REQUEST FOR PLANNING COMMISSION ACTION

Meeting Date:	October 3, 2024
Item Name:	PUBLIC HEARING - Site Plan & Design Review and Variance – 80 8th Street
Originating Department:	Community Development
Presented by:	Ethan Nelson
Previous Commission Action (if any):

The City has received Site Plan & Design Review and Variance Request applications from Saltire, LLC for the property located at 80 8th Street to construct a 24,640 sq. ft. industrial building and site improvements which proposes a loading dock to be located along the front of the building facing 8th Street. The applicants have indicated that the variance is necessary due to steep slopes and extreme elevations that exist on the property.

1 SITE PLAN
A1 SCALE: 1" = 20'-0"

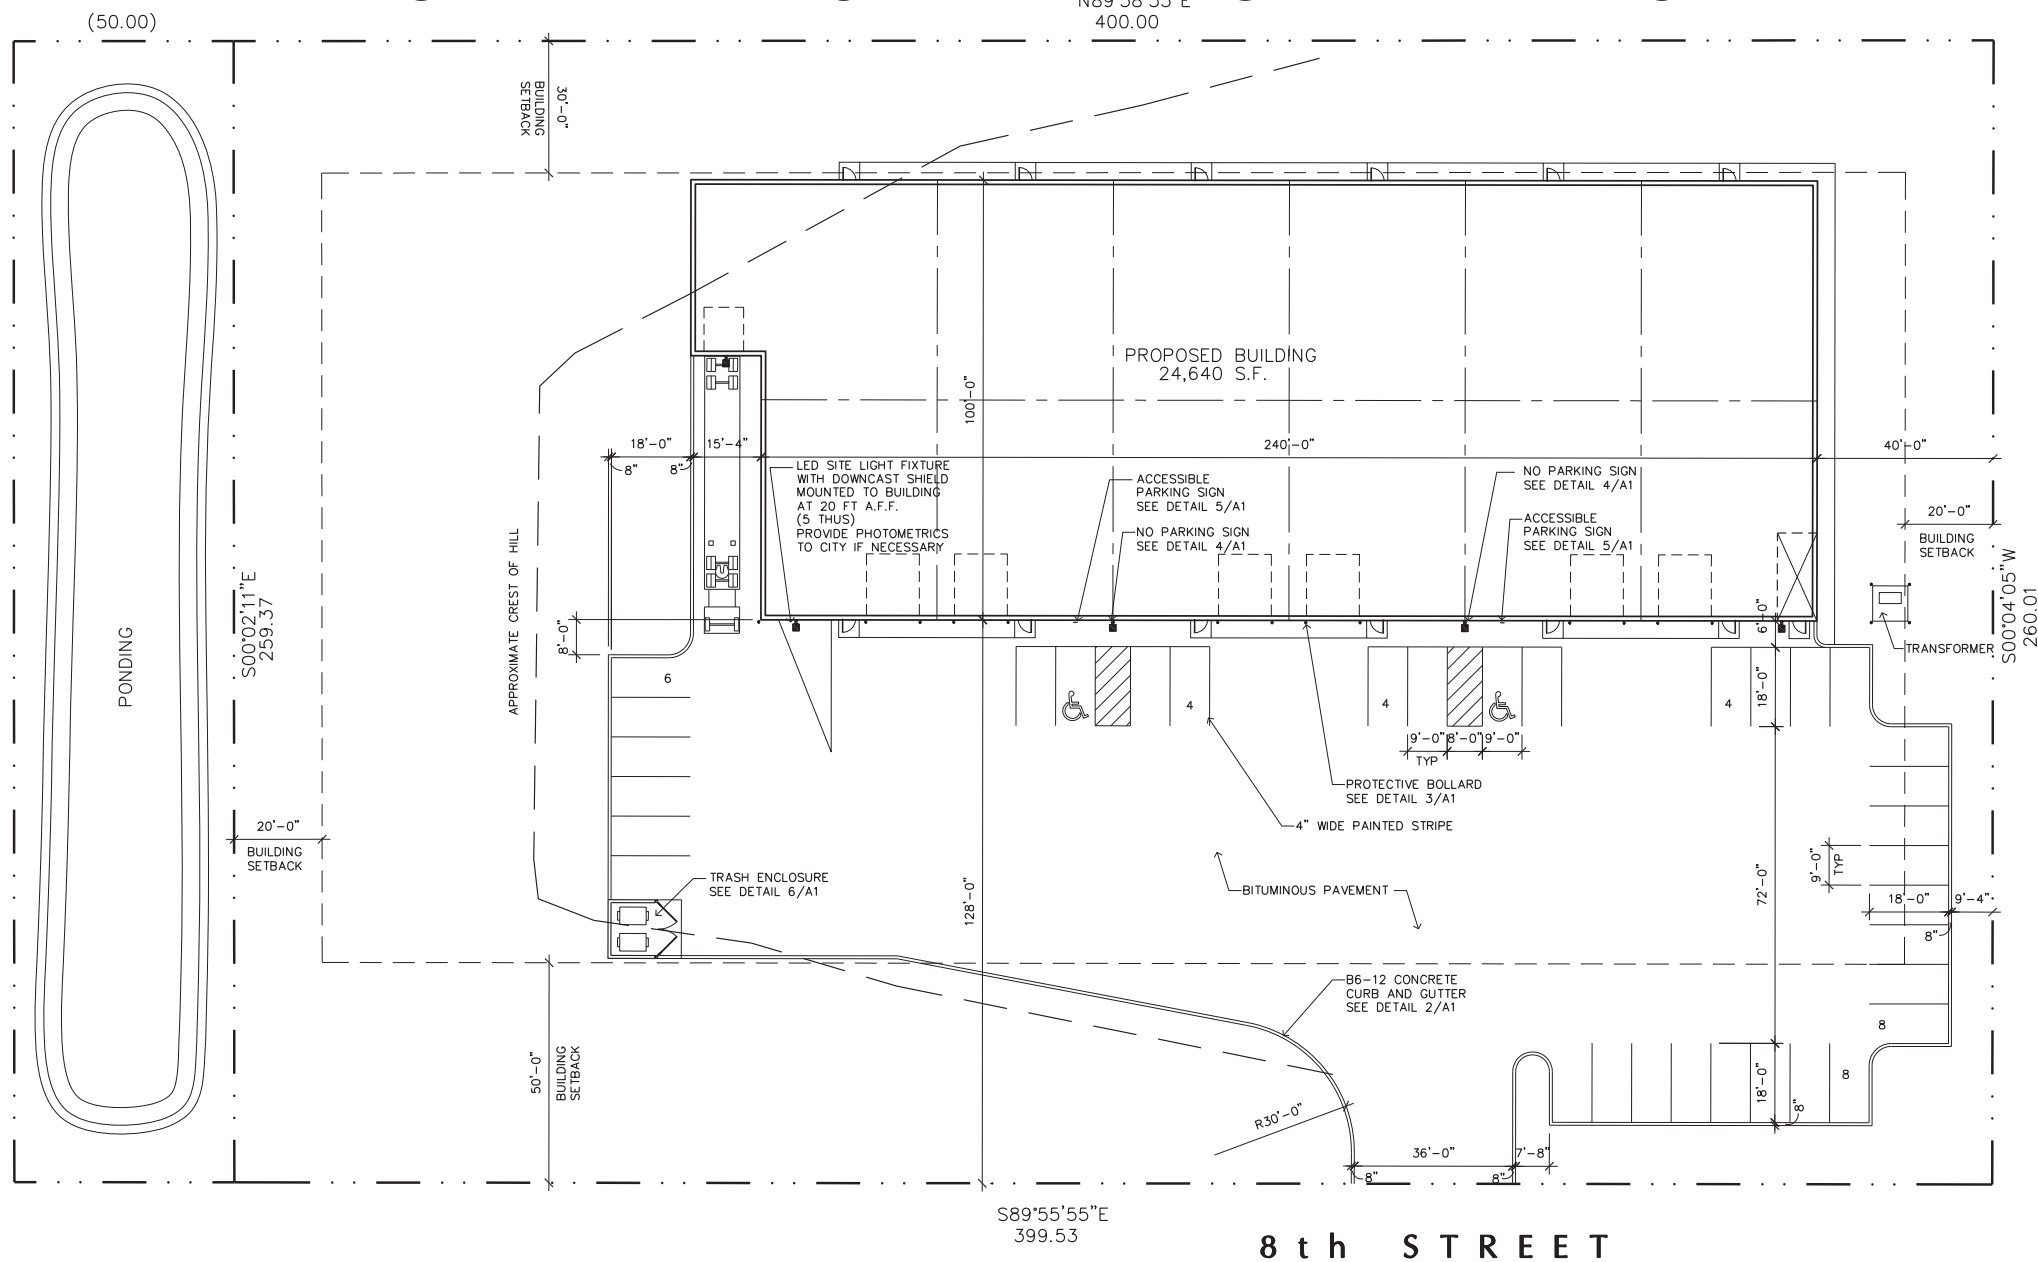
The applicant is proposing to construct 34 parking spaces as part of their site improvements to service the 24,640 sq. ft. building. 2 of those spaces are ADA compliant. The minimum parking required is 36 spaces (13 spaces required for office, and 23 required for warehousing). The applicant shall be required to add two (2) additional parking spaces.

The gross building floor area of the proposed building is 24,640 sq. ft. The applicant is proposing 37 trees. 22 trees meet the minimum size requirements. City code requires One (1) tree meeting minimum planting size (2.5 Cal. Inches for deciduous or 6 ft. in height for coniferous) is required per one thousand (1,000) square feet of gross building floor area. 25 trees are required and currently 22 trees meet minimum size standards. Further, the complement of trees fulfilling the requirements of this policy shall be not less than twenty-five (25) percent deciduous and not less than thirty-three (33) percent coniferous.

The plans show an exterior trash enclosure on the south-west side of the property. The elevations shown on the plan page A1 appear to propose material consistent with the principal structure as noted in the code language above.

8. The applicant shall submit a revised landscaping plan, meeting the 25 tree requirement.
9. The applicant shall submit lighting specifications for the proposed fixtures at the time of permit submission.

13. The applicant shall revise the off-street parking to meet the required 36 parking stalls.

BUILDING ELEVATIONS

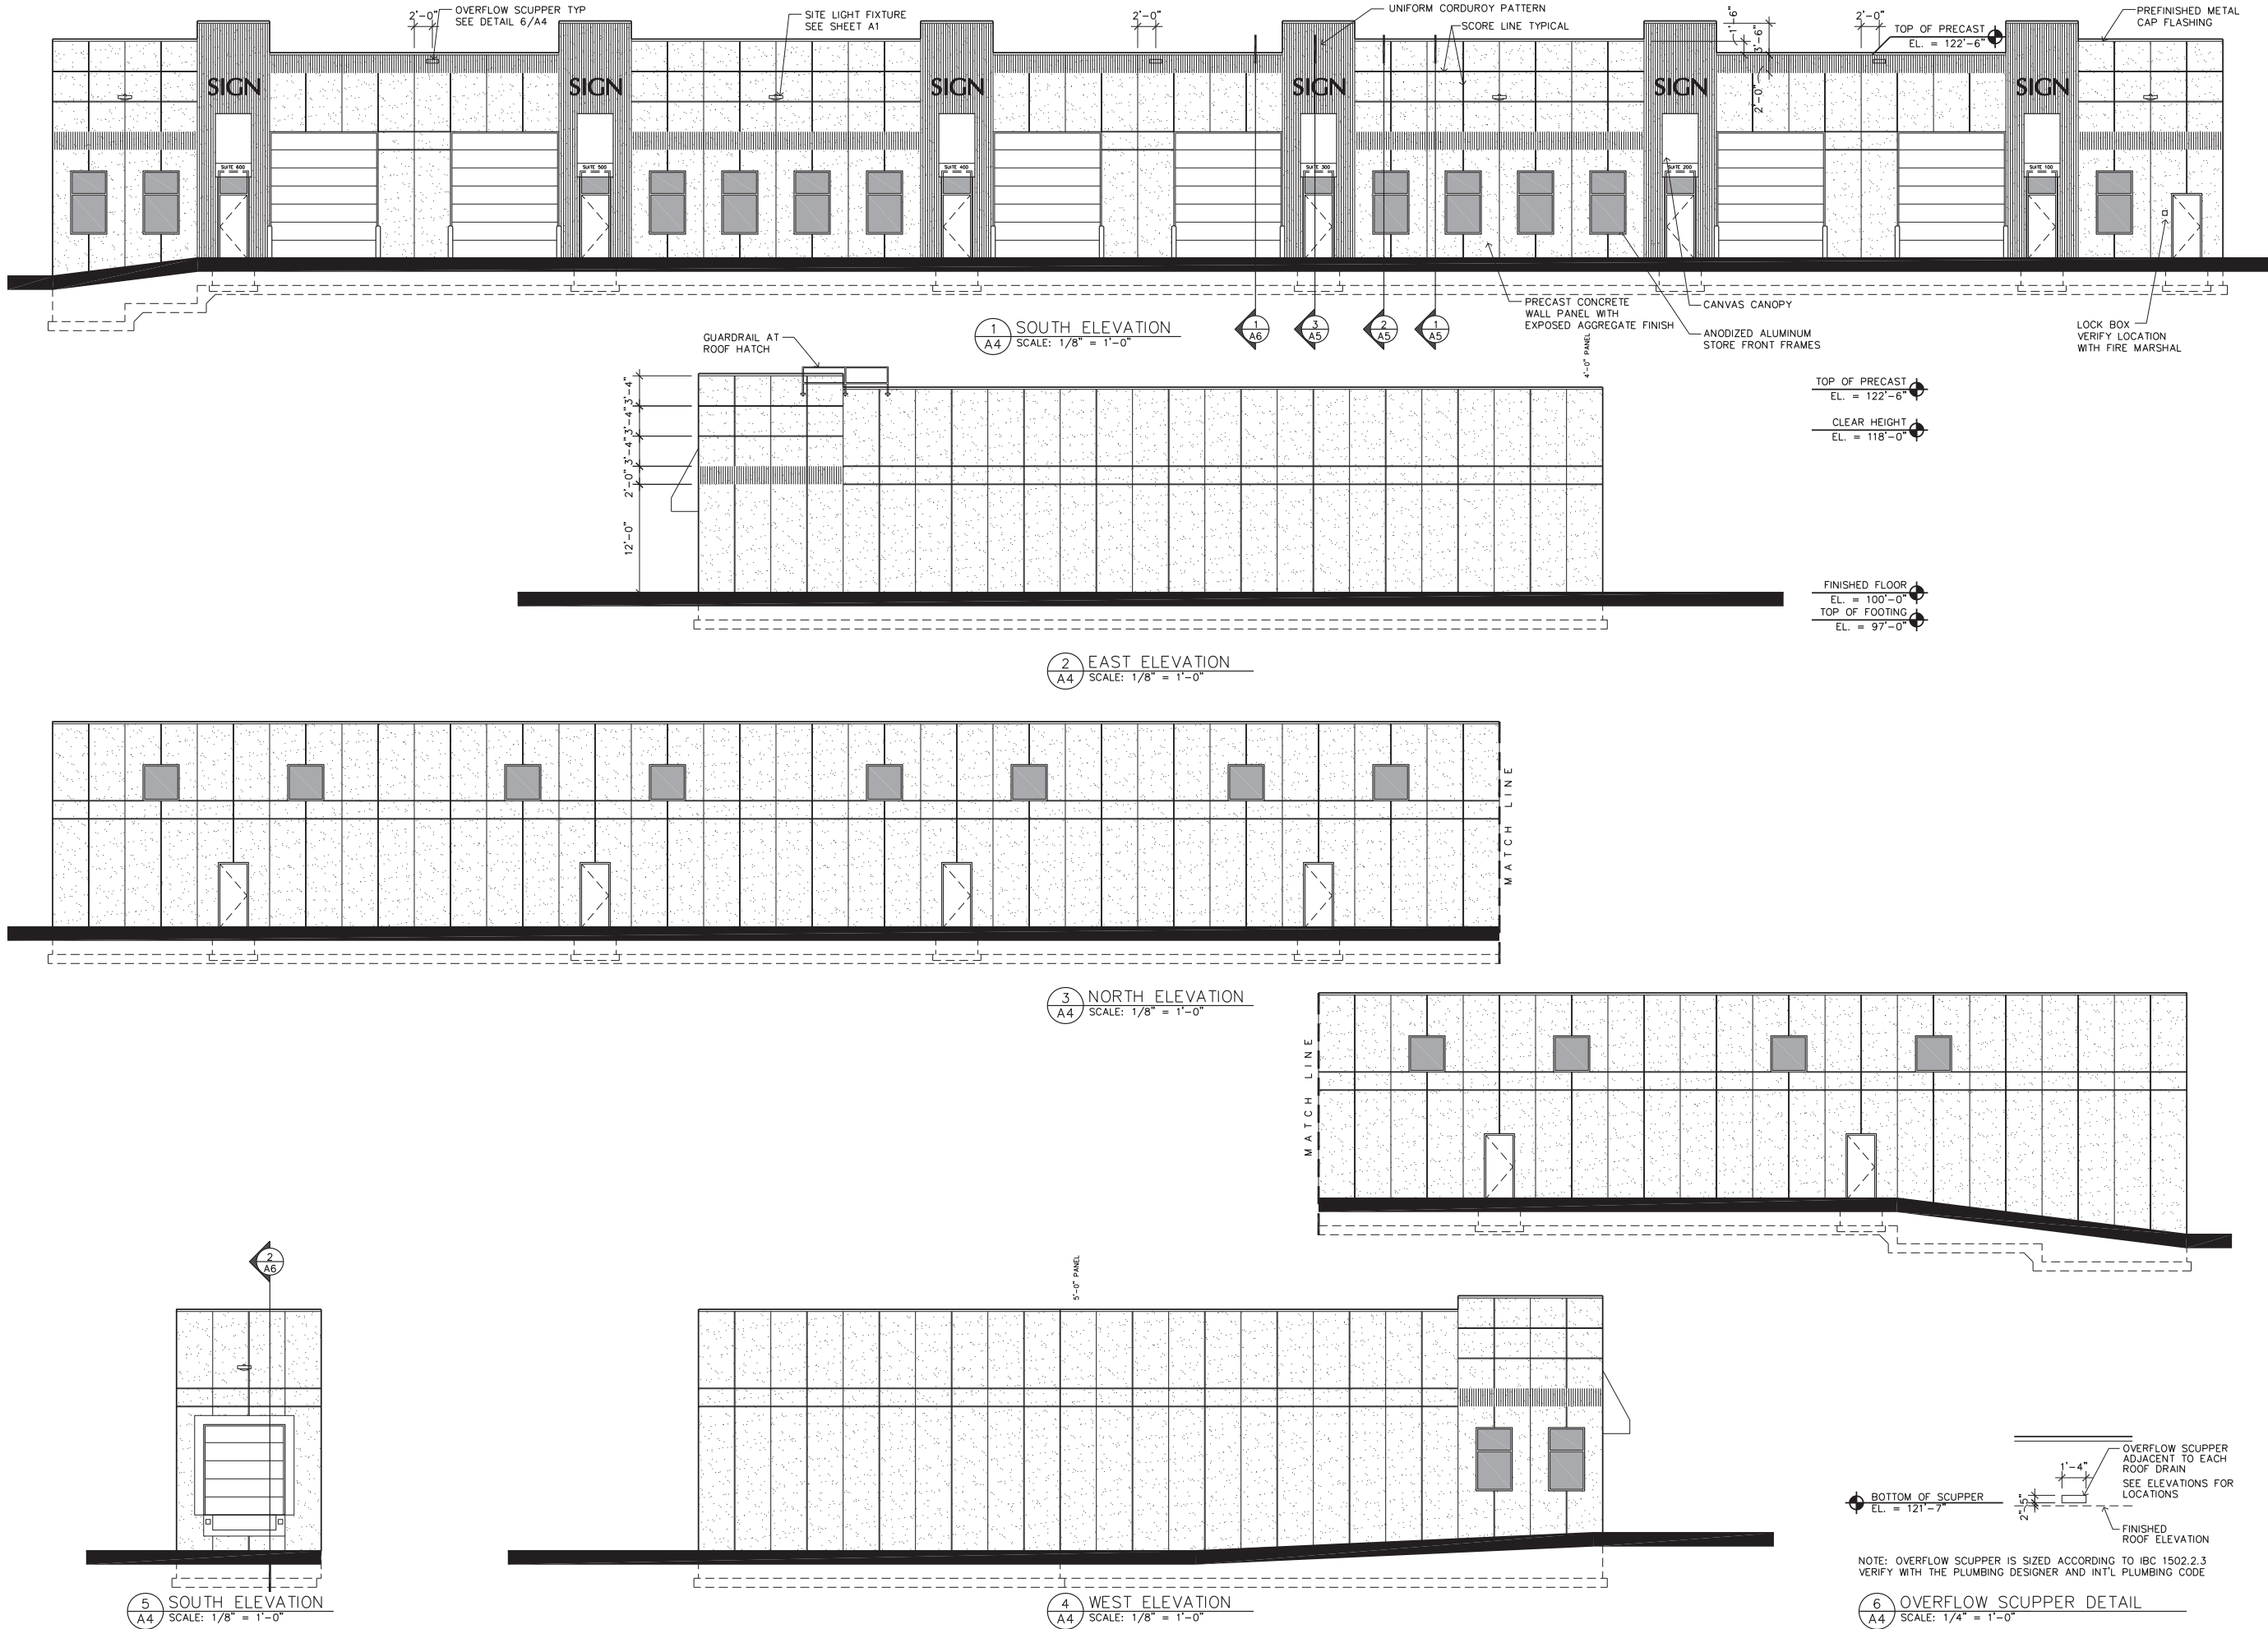
The applicant indicates one ground mounted unit on the proposed site plan. There does not appear to be proposed rooftop mechanical equipment on the roof plan or elevation plans A3-A4. All proposed and future outdoor and/or rooftop mechanical equipment shall be screened from neighboring properties and public road right-of-way in compliance with the City Code.

Section 900.08, Subd. 1.C provides standards for exterior lighting. The applicants have noted lighting on Sheet A-1 and A-4 that generally appears to meet City code requirements. The applicants shall submit lighting specifications for the proposed fixtures at the time of permit submission.

11. Any/all exterior rooftop or ground mounted mechanical equipment shall be screened from public streets.
12. The applicant will be required to obtain Carver County Watershed Management Organization (CCWMO) approval and permitting for erosion control and stormwater management. A copy of any permits/approvals should be submitted conditional to Final Site Plan approval.
